Re: Final Plat-Tartan Ridge, Section 5, Part 2

12-089FDP/FP
Final Development Plan/Final Plat
Tartan Ridge, Section 5 - 2
7610 McKittrick Road

Tartan Ridge Section 5 Final Development Plan Application

TARTAN RIDGE SECTION 5 PART 2

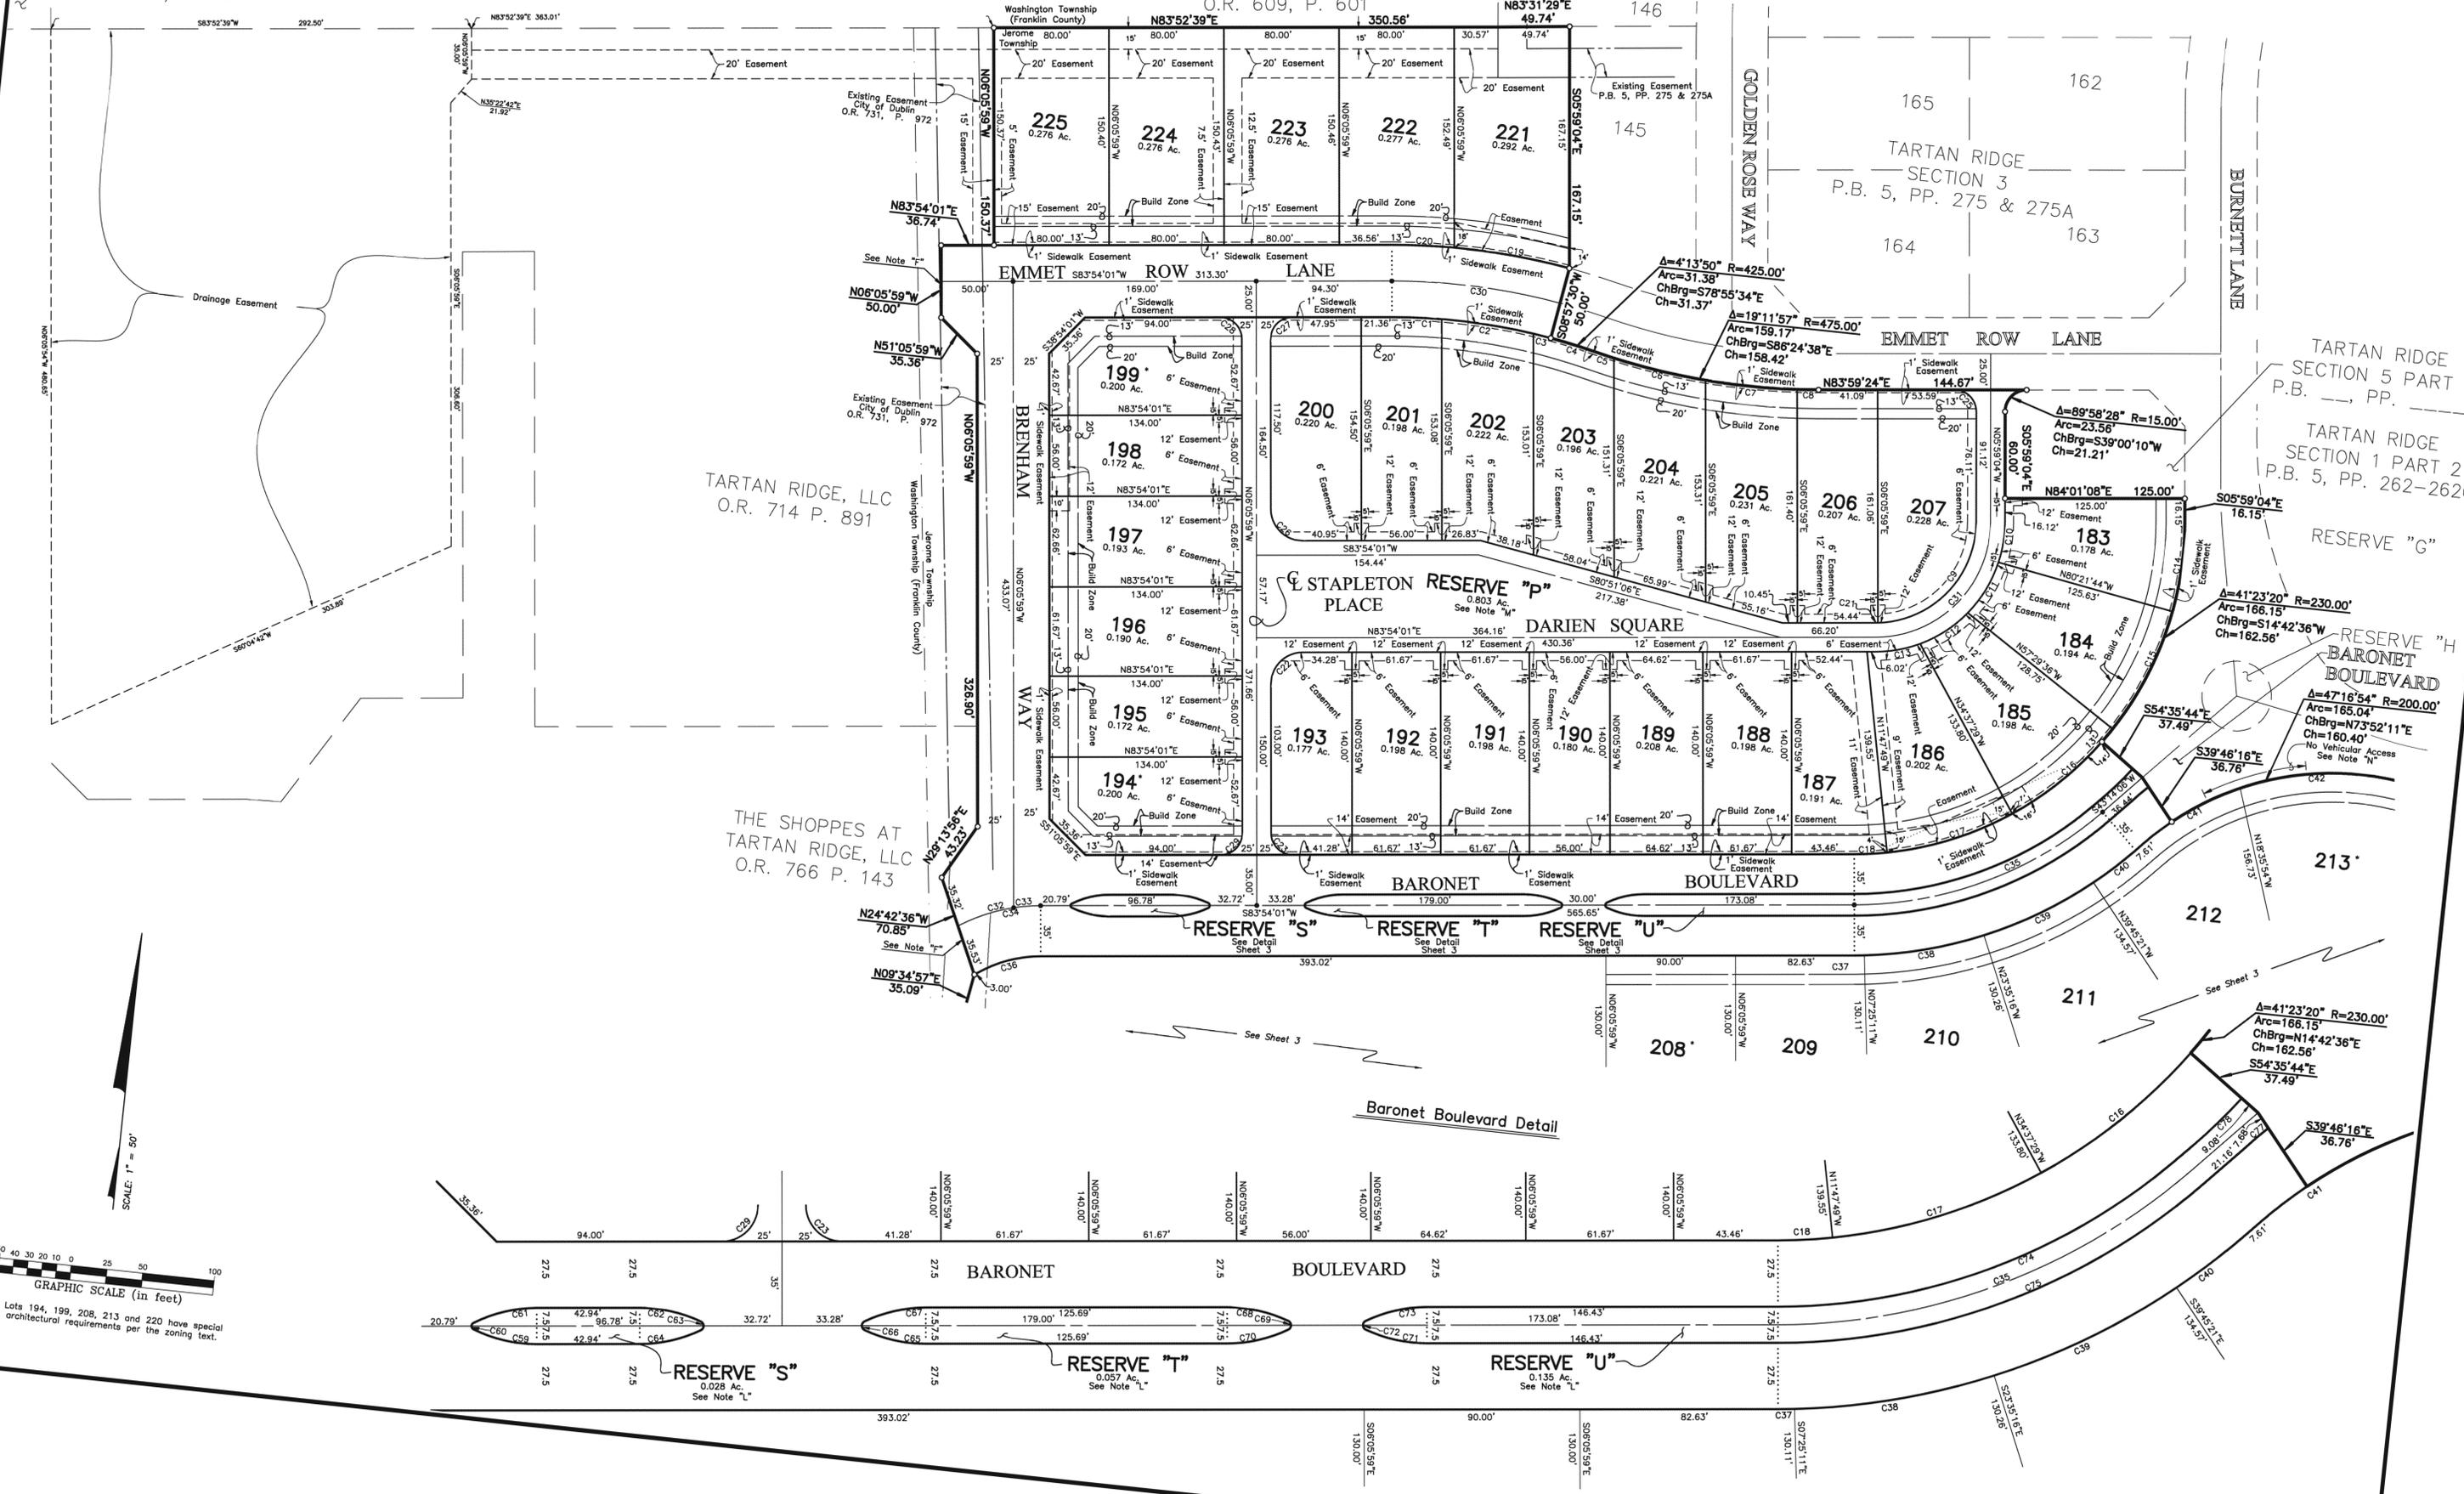
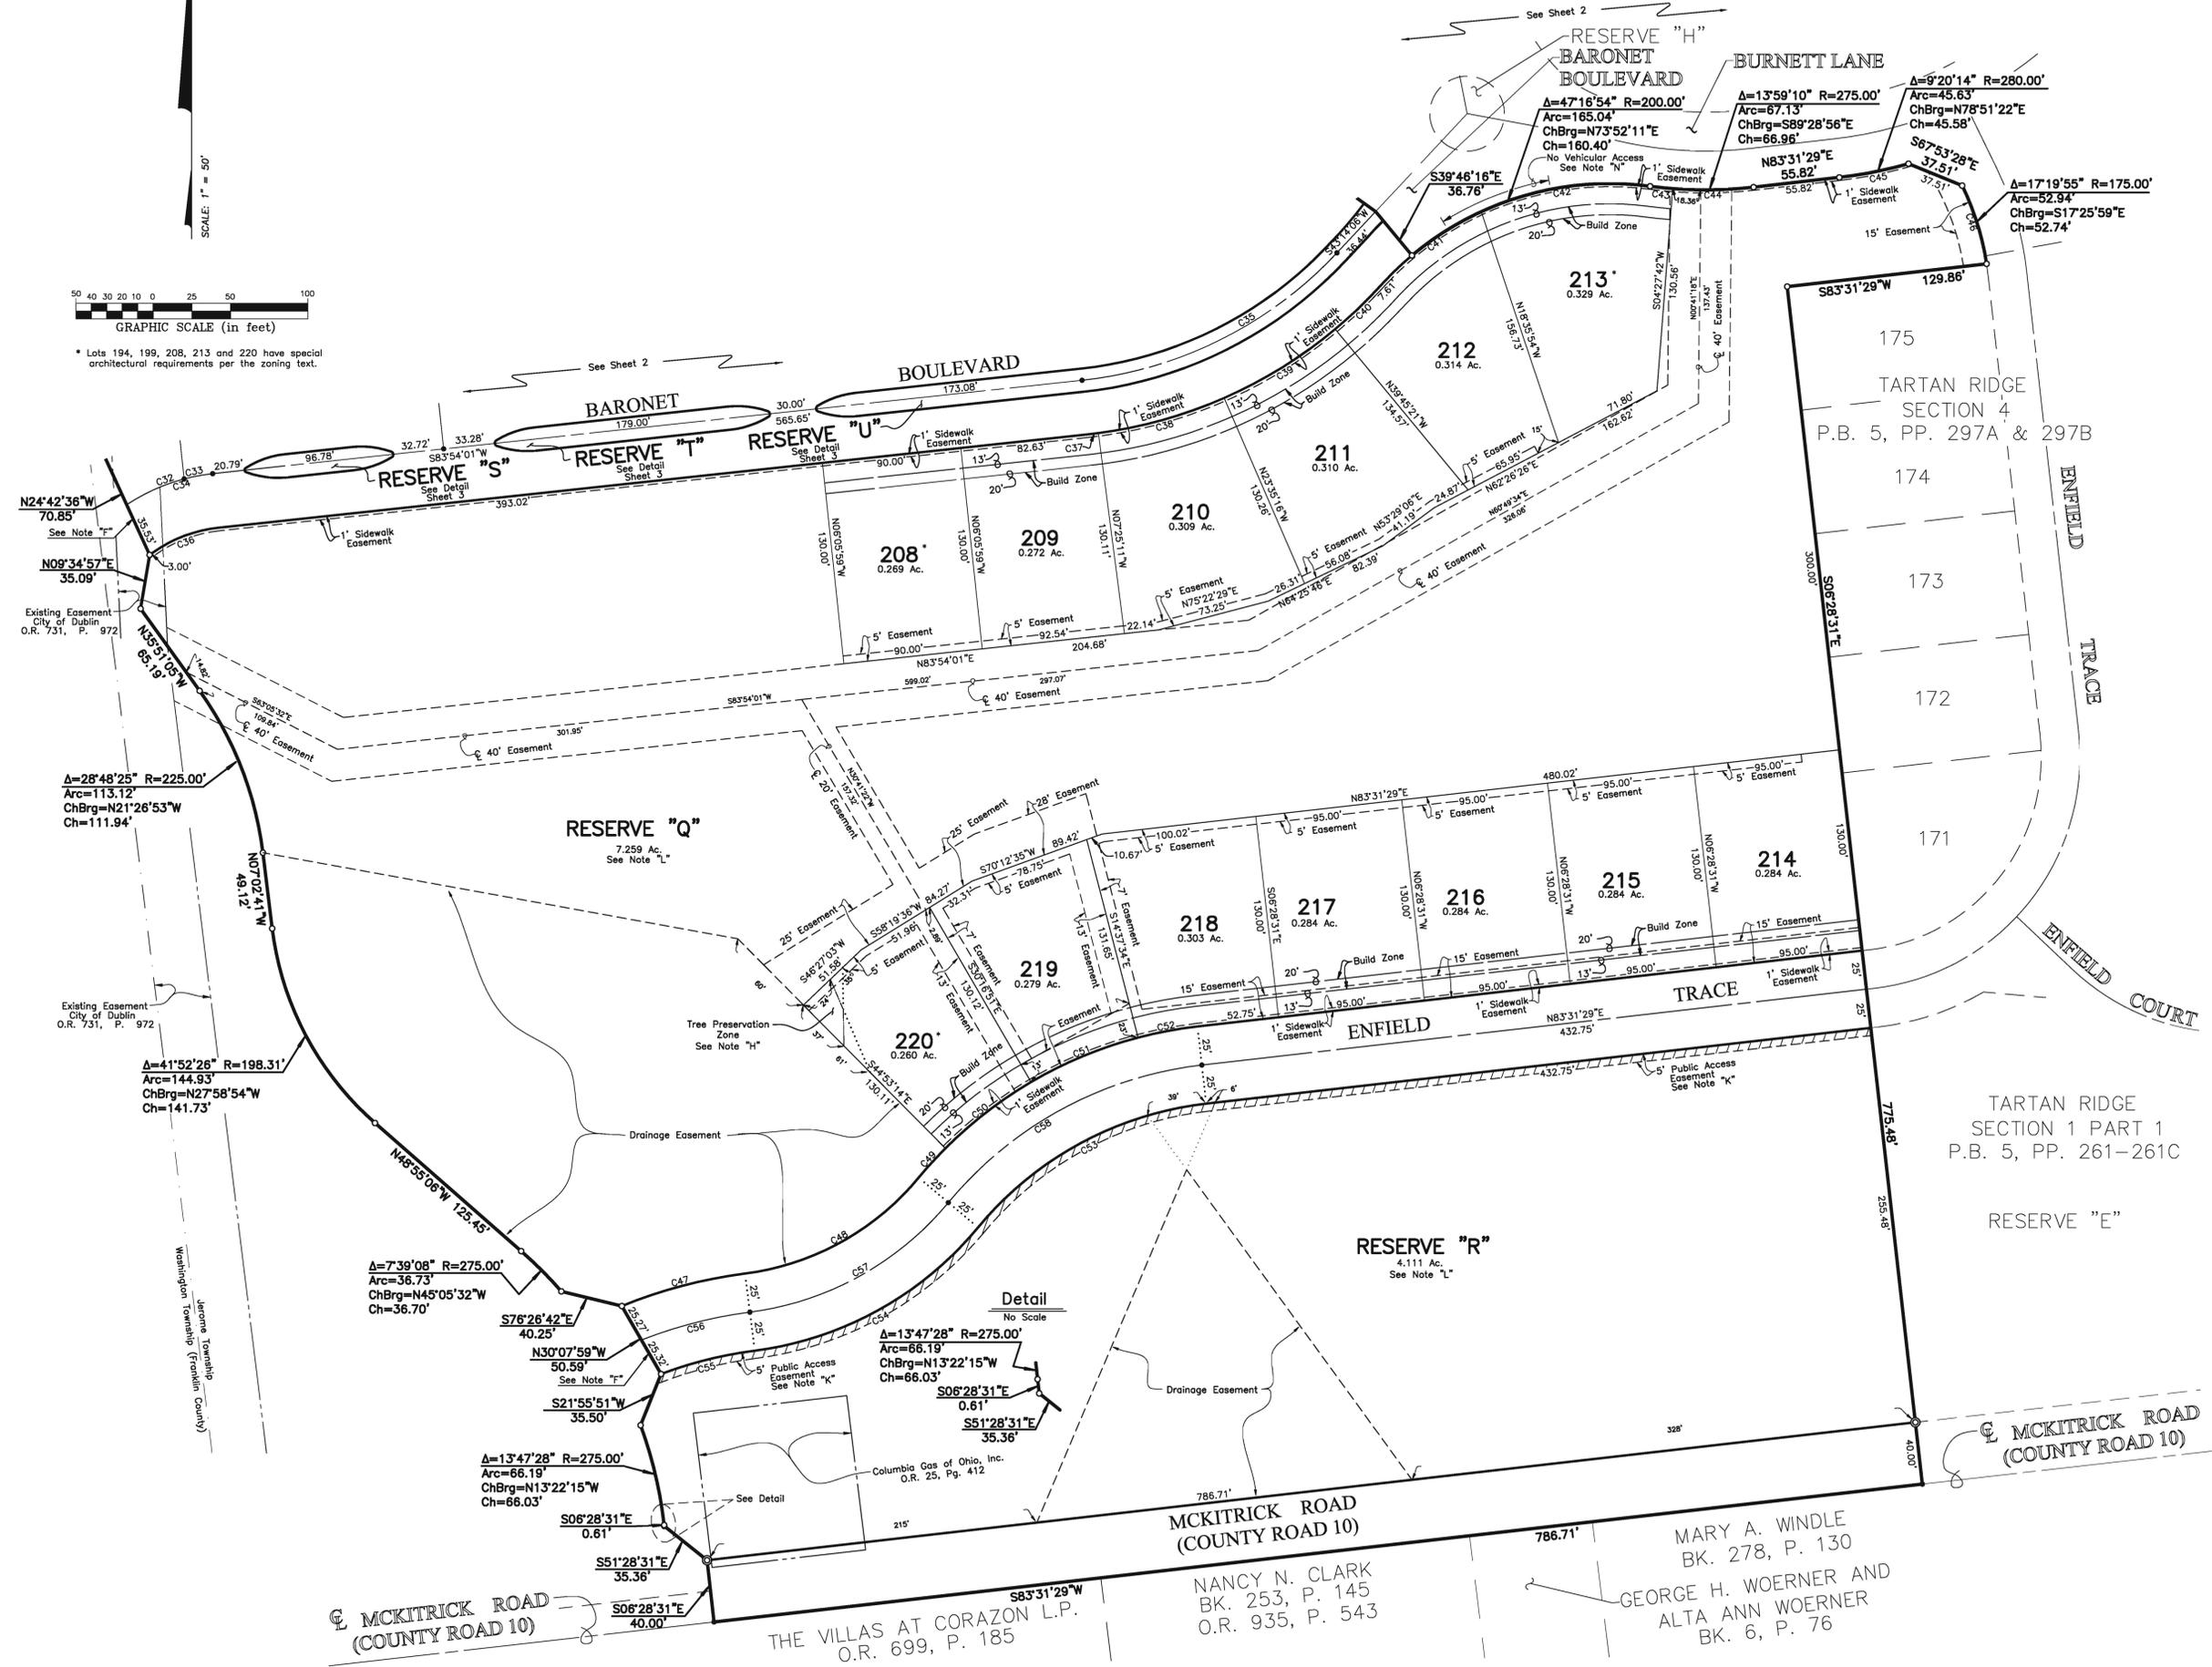
- 1) That any technical adjustments be made to the plat prior to submission to City Council, including noting specific architectural requirements for Lots 194, 199, 208, 213, and 220.

* Lots 194, 199, 208, 213 and 220 have special architectural requirements per the zoning text.

Proposed Final Development Plan

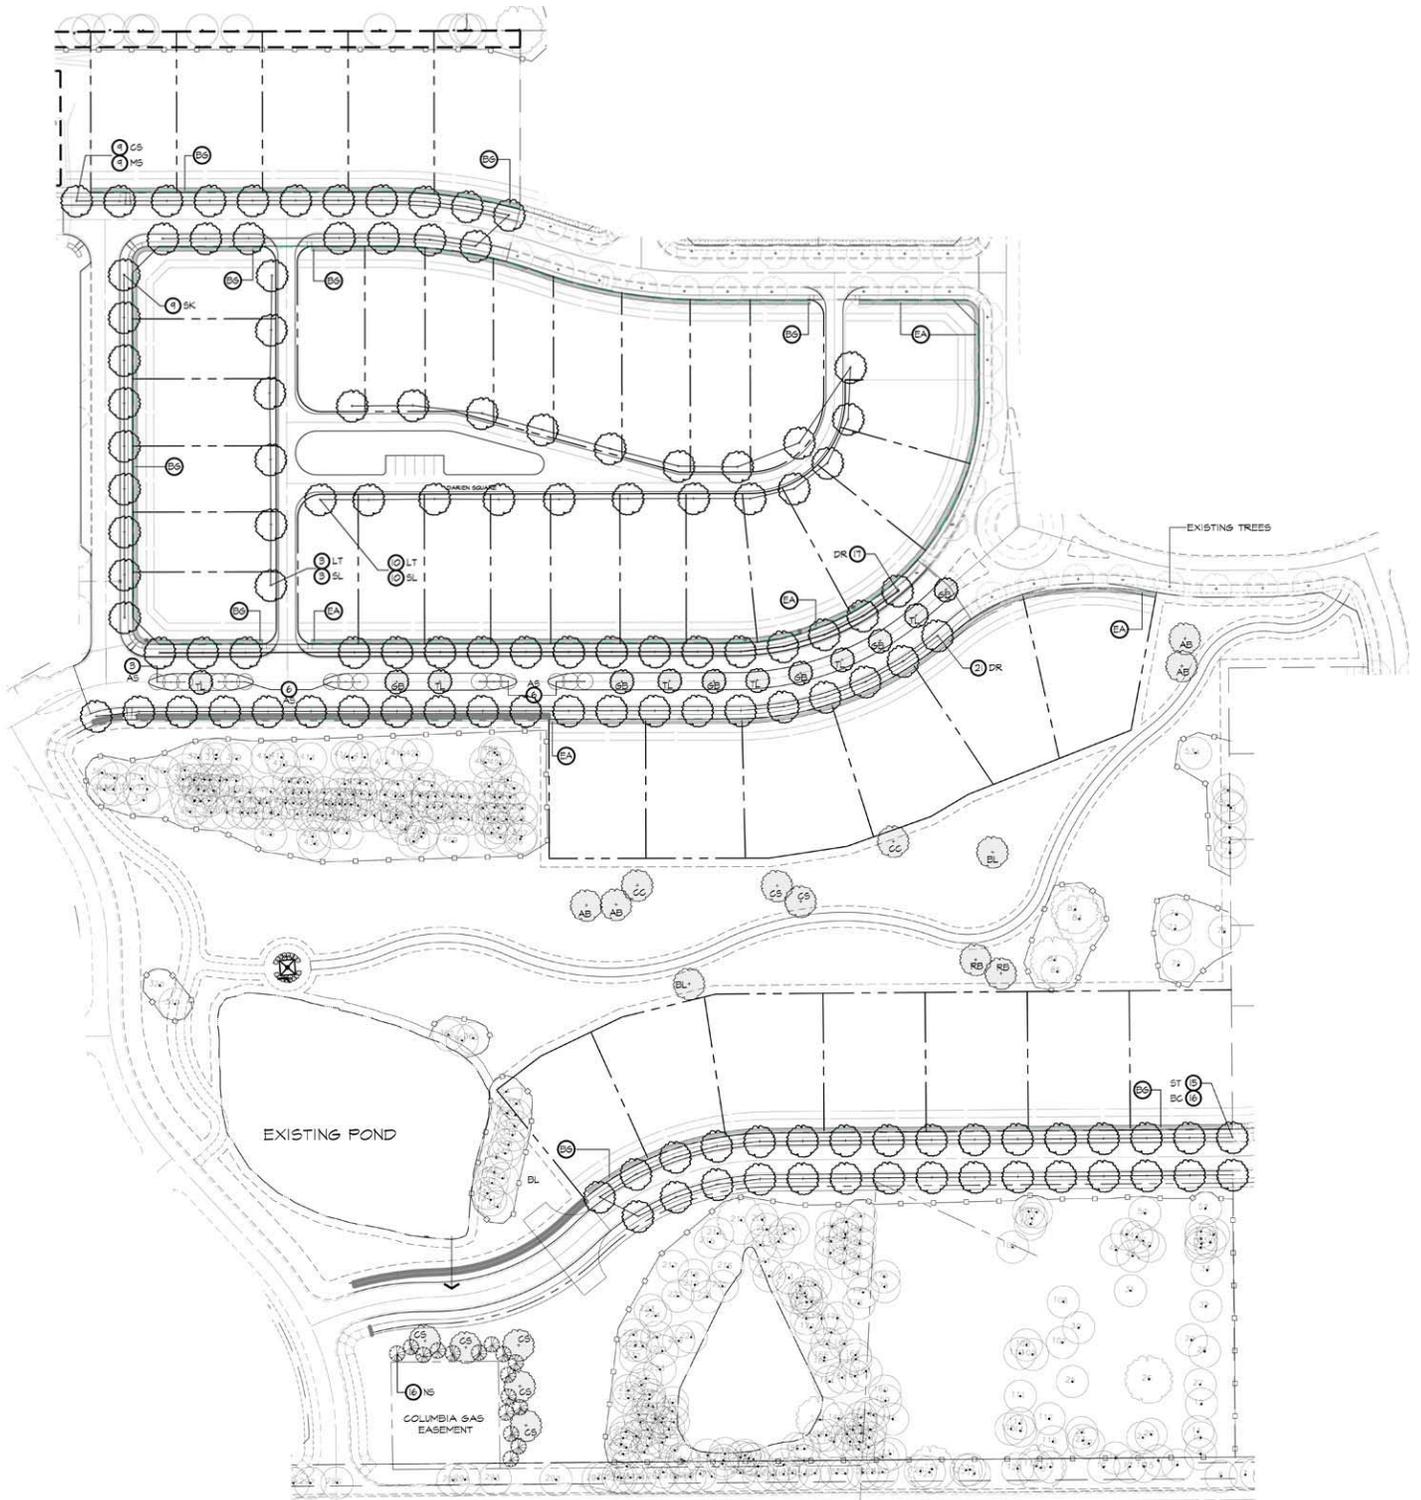
- 1) That the diversity matrix be revised to include the alley-accessed lots;
- 2) That the applicant install ribbon curb along the pavement edge of the alleys to clearly delineate the edge of the alley;

- 3) That the plans be revised to include one-way traffic restriction notes for designated alley segments;
- 4) That the applicant provide a bikepath along the south side of Enfield Trace instead of the sidewalk shown along the northern edge of Reserve "R";

- 5) That the applicant not remove protected trees #947 and 952 through 968 west of Lot 225 as part of this proposal and work with Planning and Engineering to relocate storm structure #3 out of the critical root zones of protected trees in the area;

- 7) That the plan's landscaping extend along the western boundary of the fence around the Columbia Gas easement in Reserve "R";
- 8) That the trees within the alley landscape island be revised to Japanese Tree Lilac instead of the proposed Tulip Trees;

- 10) That the applicant revises the landscape plans to indicate tree protection fencing on the north side of the proposed sewer and grading work west of Lot 225, remove statements regarding tree replacement credits in the legend and the plant list;

- 11) That the applicant revise the plant list to include "EA – Dwarf Burning Bush";
- 12) That the applicant install decorative pavers on the alley loaded driveways; and,
- 13) That the hedges be placed at least 3 feet off the sidewalk along the frontage of the homes and at least 5 feet off the curb along the landscape island, subject to approval by Planning.

The applicant has addressed Conditions 1, 4 through 8, 10, and 11. Conditions 2, 3 and 12 will be required to be addressed as part of the construction document approval, and Planning will work with the developer to address Conditions 9 and 13 throughout the development of this Section.
